**ADDENDUM
NO. 2**

Richland Bean Blossom Schools Roofing & Mechanical Renovations
Various Schools Locations
Ellettsville, IN 47429

PROJECT: Richland Bean Blossom – Roofing & HVAC
Junior High School

DATE OF ADDENDUM: February 10, 2026

1 ROOF DETAIL
1-1/2" = 1'-0"

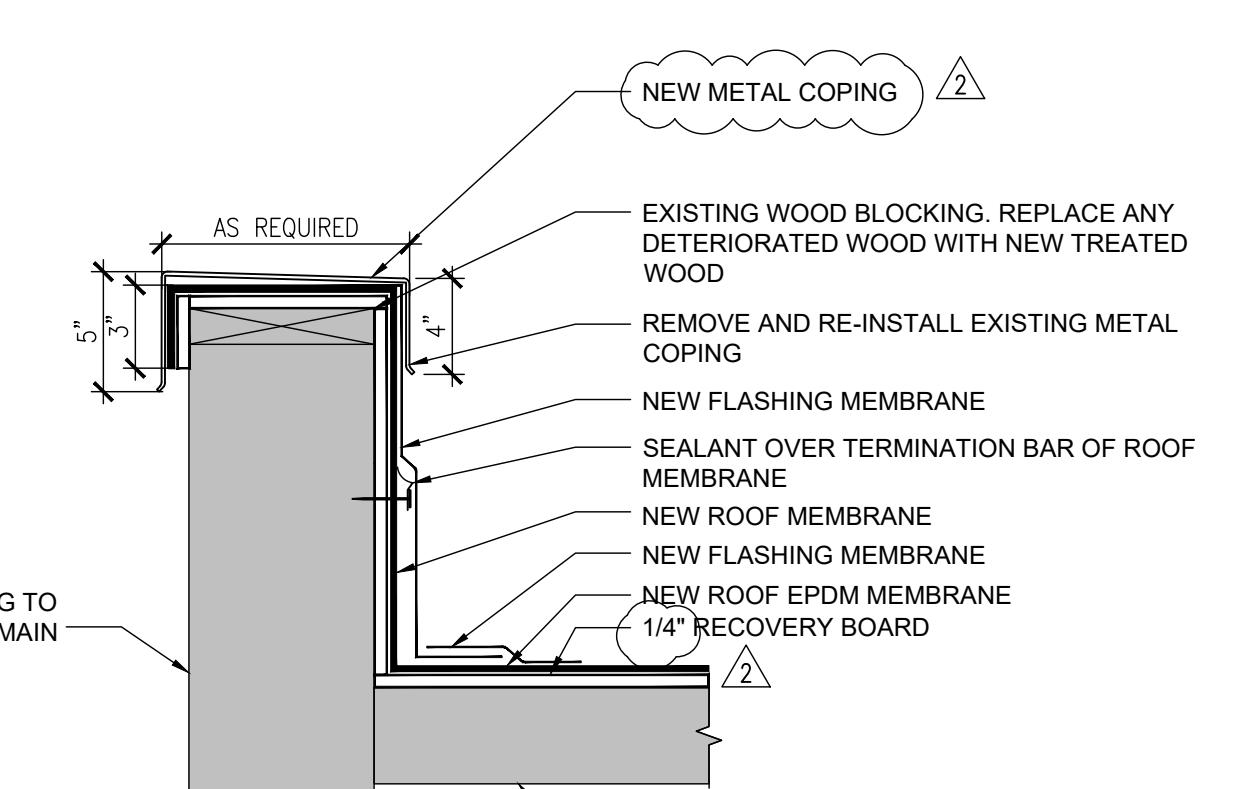
- All the recovery board shall be 1/4 inch thick.
- All parapet coping shall be new.
- New roof membrane shall be installed vertically and continue under the existing metal roof.
